VALVE WITH TANK

Separated-tank solution for towed vehicles

TOWED VEHICLES |

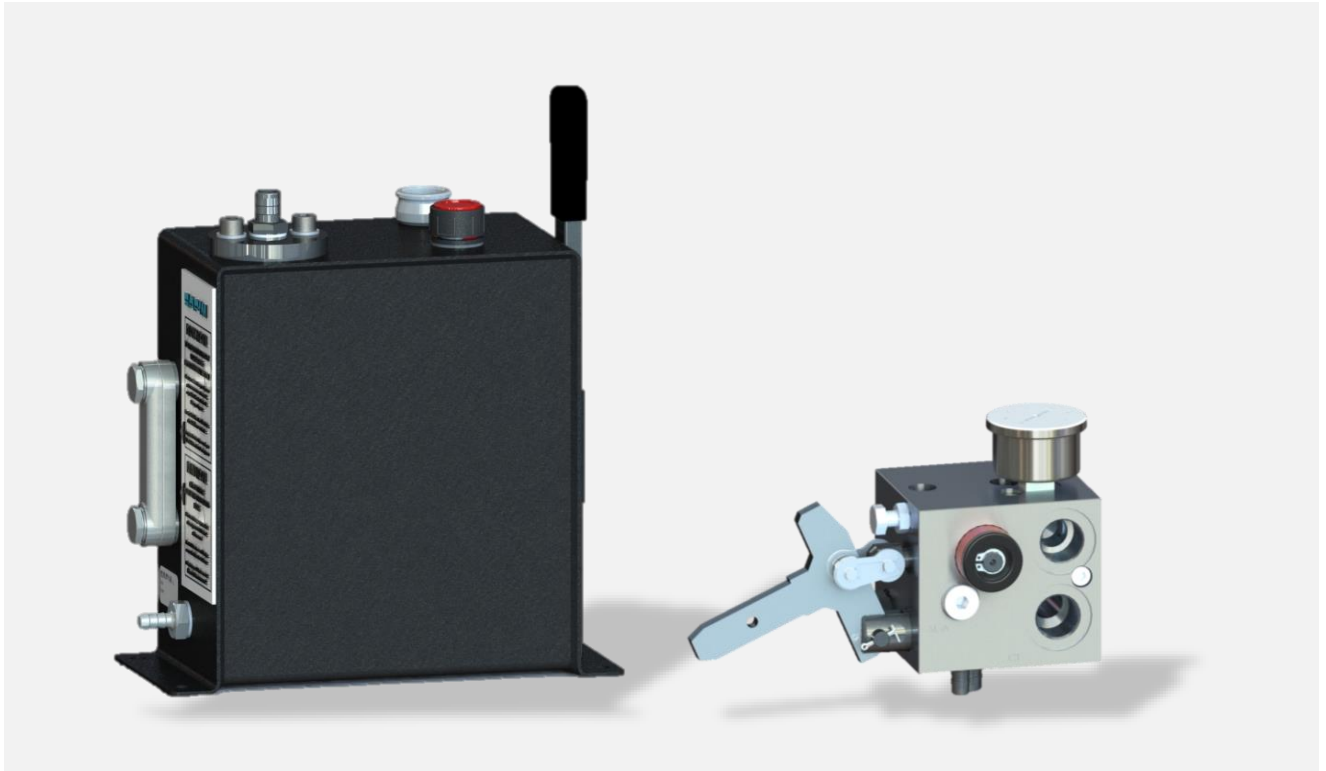
The new design update includes:

- **Easier positioning:**

Valve and Tank **can be installed separately** one to the other.

Their connection is carried out by using hydraulic hoses.

This solves installation problems typical of vehicles with **small installation space availability**.

- **New indication system** of manual operation mode:

A red indicator appears when selecting the manual valve mode **and disappears automatically as soon as the trailer is connected back to a dual-line tractor**.

- **Overpressure protection** for supplementary line:

The **relief valve prevents the pressure in the SL line from exceeding** the safety limit avoiding accidental damages to the system.
